RE: **Small Cell ROW Use Permit Application(s)**
Reasons for Denial of ROW Use Permits 1701-153 (MIS12), 1701-158 (MIS17), 1701-130 (MIN05)

RE: **Small Cell ROW Use Permit Application(s)**
 Request for Additional Information – MIS01 through MIS24 and MIN01 through MIN15

RE: **Small Cell ROW Use Permit Application(s)**
Second Request for Additional Information – MIS01 through MIS24 and MIN01 through MIN15

Alternative Site Analysis MIN05

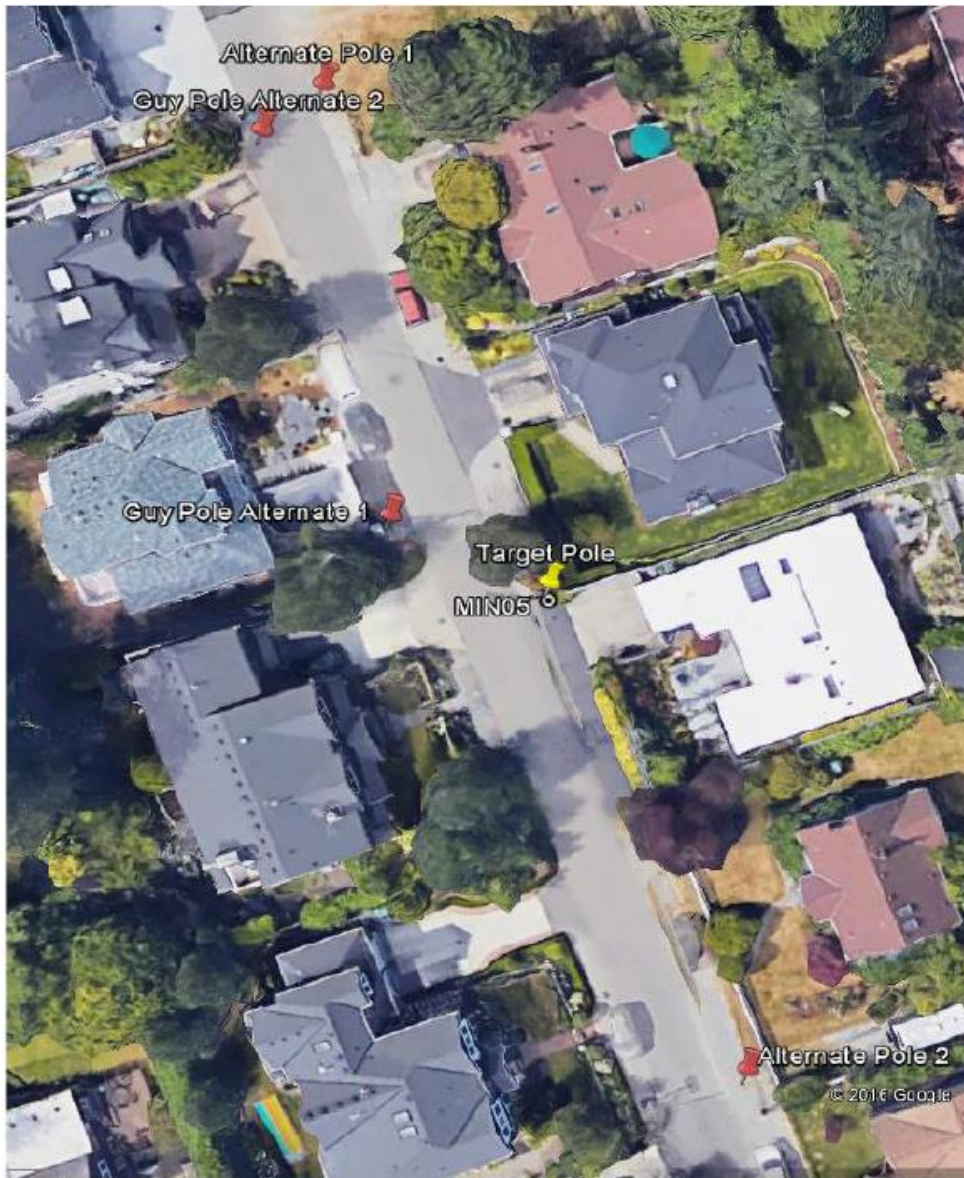
Guy Alternate Pole 1 is located in someone's walkway on private property. (See attached photo and parcel information found on the King County Assessor's Office Parcel Viewer.

Guy Alternate Pole 2 is 150' away from the target pole.

Alternate Pole 1 is 150' away from the target pole.

Alternate Pole 2 is 150' away from the target pole.

MIS12

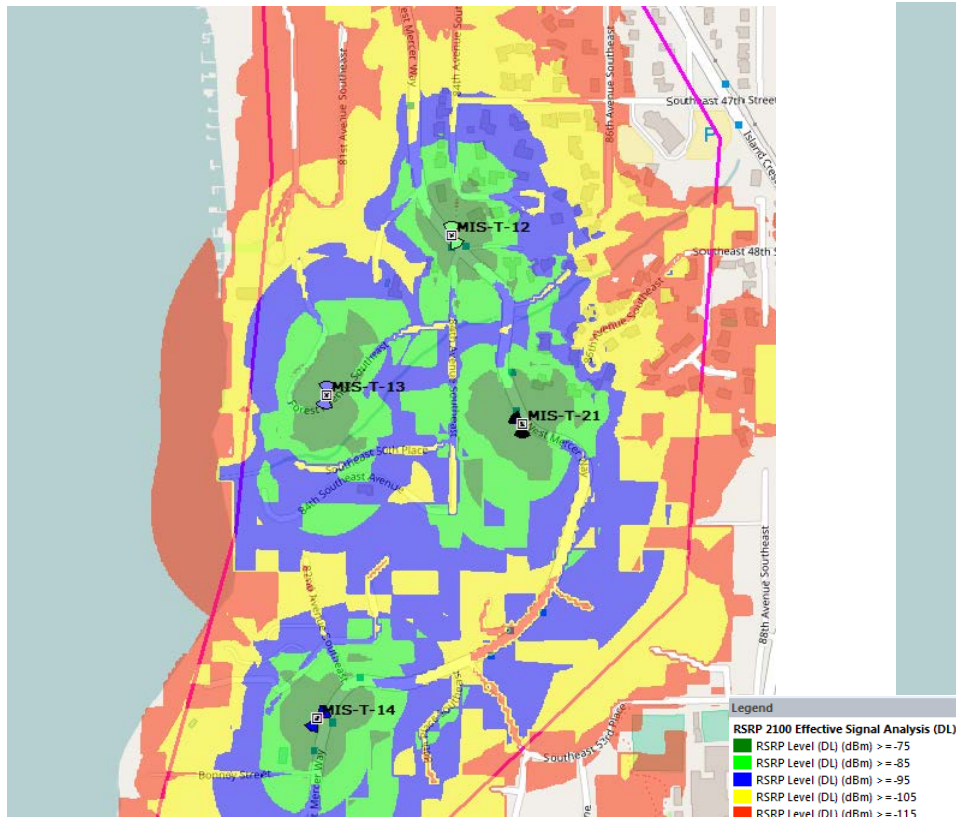
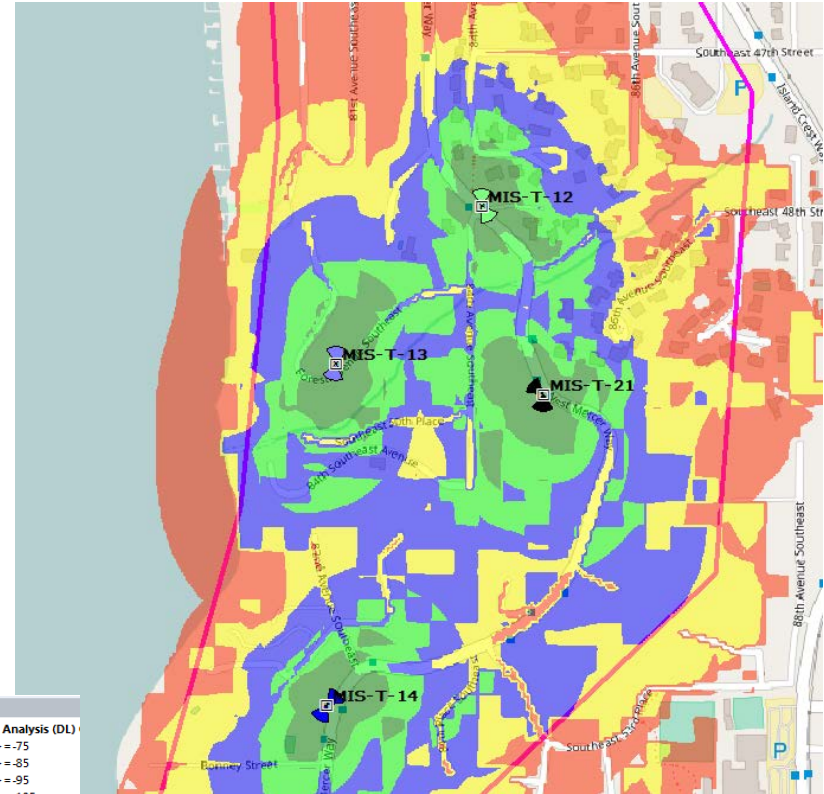
Alternate Pole 4 will not propagate as to fill the significant gap in coverage. See propagation map.

As shown in the attached signal propagation map, when site MIS12 is moved to alternative pole #4, there is a significant gap in coverage toward the southwest and northwest where the signal strength is worse than -85 dBm. When site MIS12 is located on its originally proposed pole, it provides service in the significant gap in coverage.
